Vox JMI AC30/4 Layout	
Preamp Chassis	
Dated: June 16, 2023	1 of 2
Drawn By: J. Almeida	Revision: R6

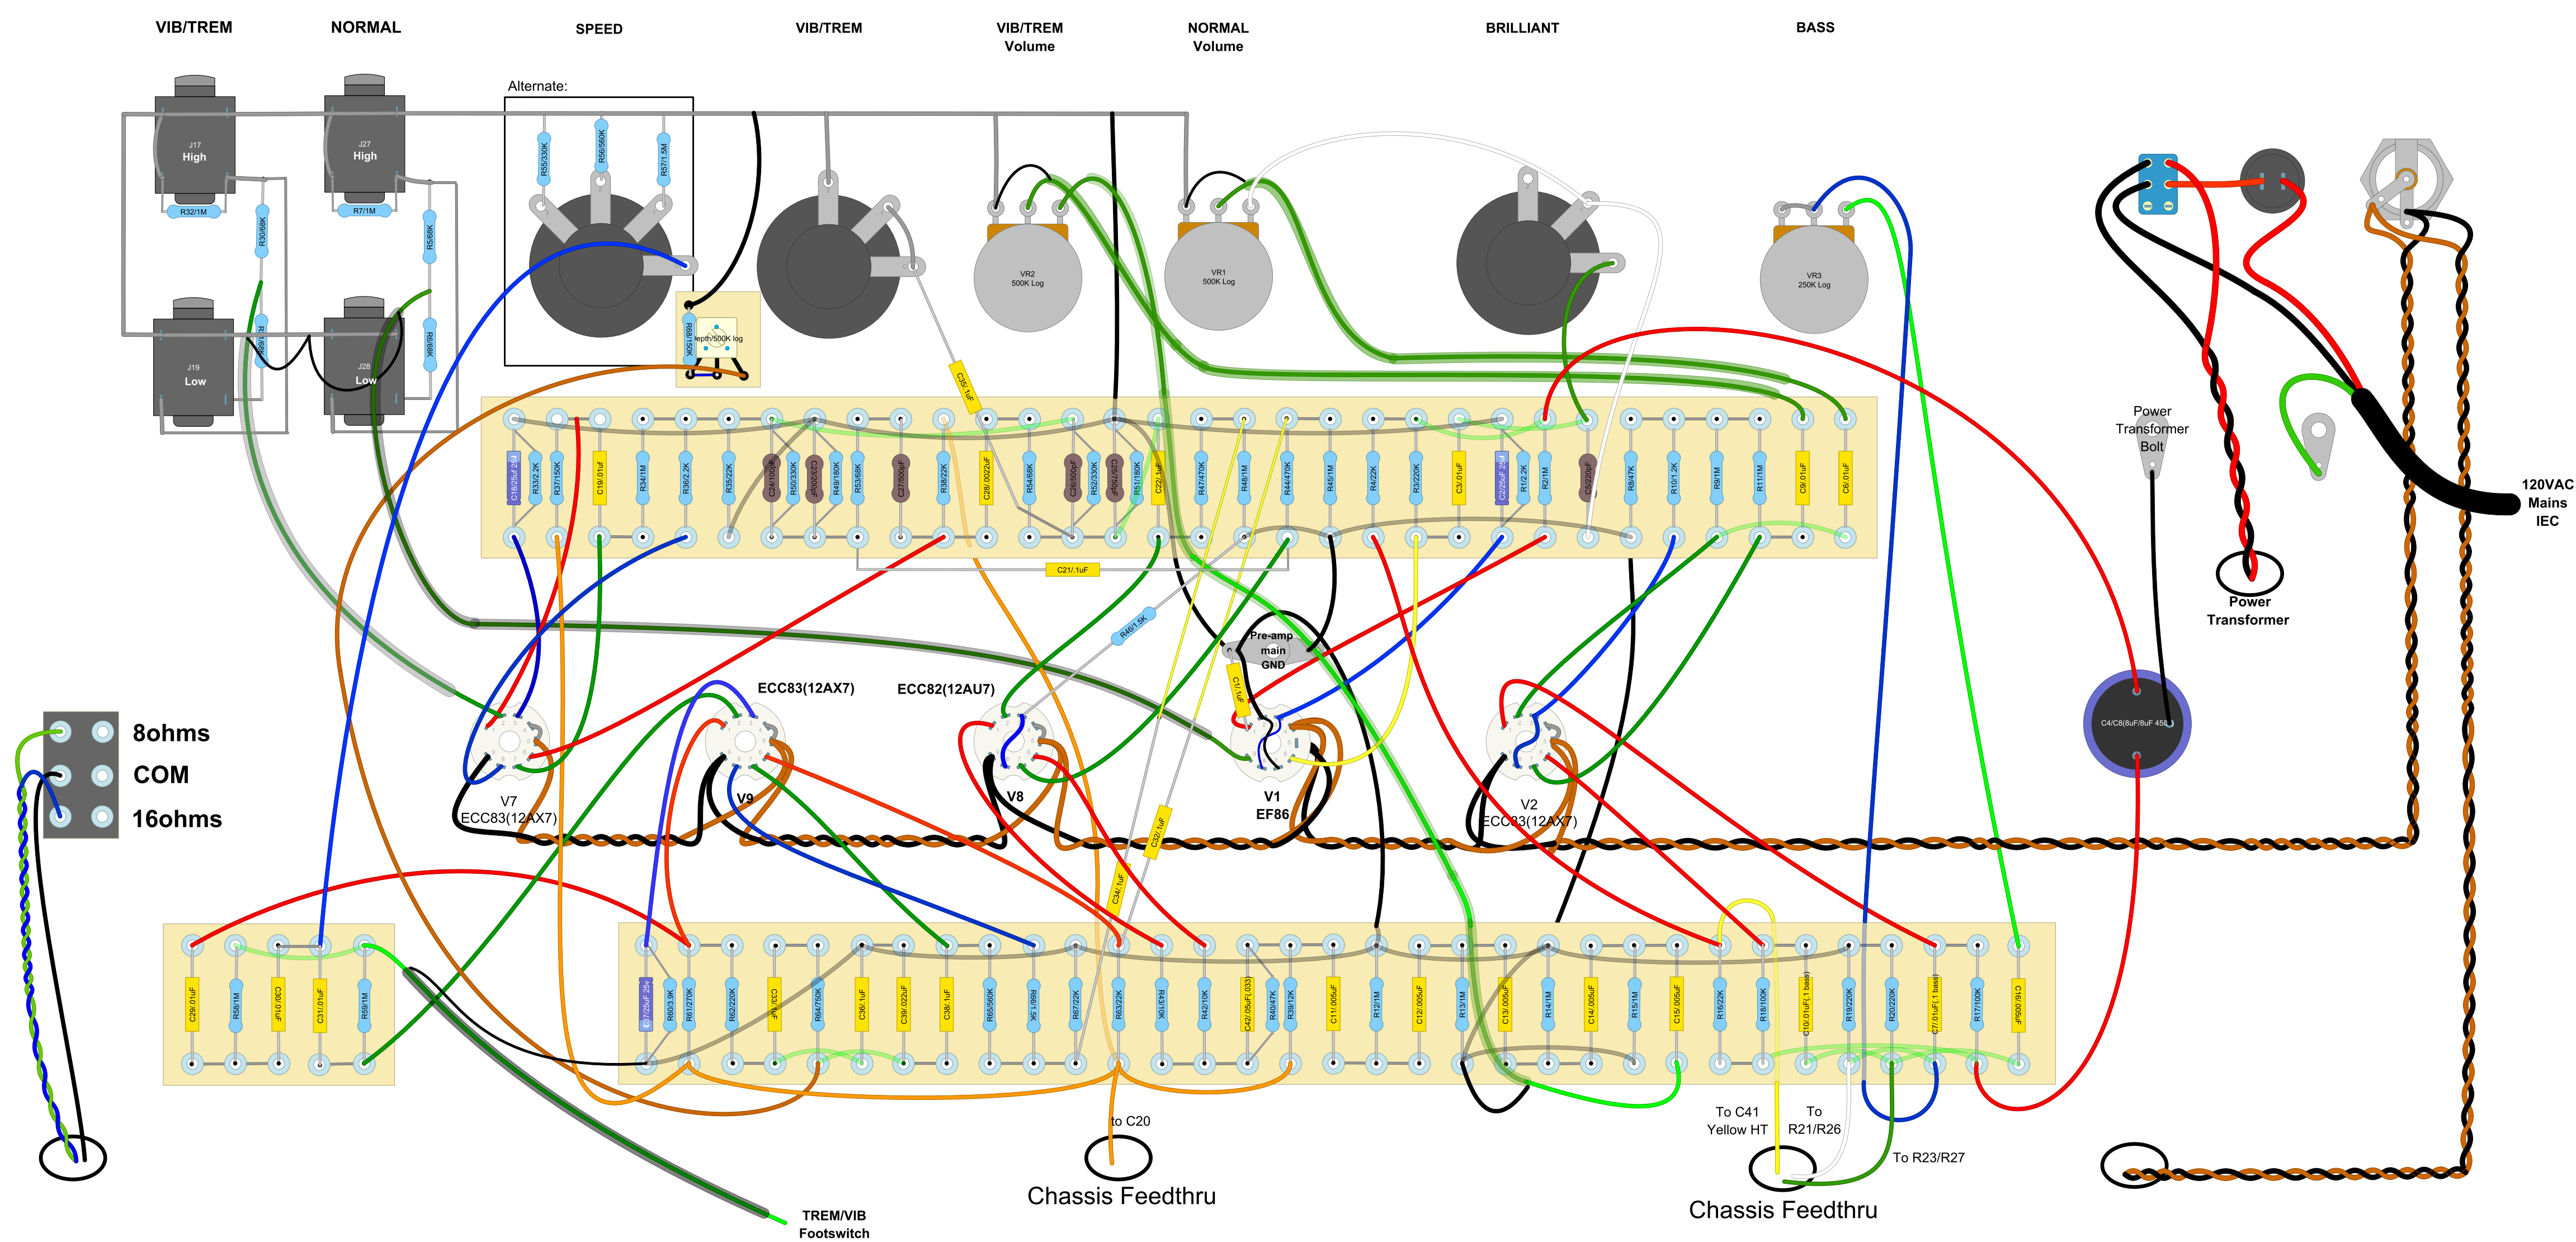
R6- Adds missing Jumper on C22/R51. Adds ground on R45. Adds missing jumpers on R45/R8. Adds missing Jumpers on R16/R18/R17.
R5- Corrects Input Jack Hi/Lo. Correct lead lug placement on alternate Vib/Trem Speed pot.
R4- Corrects Input Jacks(Delete Jumpers on High Jacks)
R3- Added Alternate Vib/Trem Speed Pot
R2- Corrects Vib/Trem board component names. Also add component values
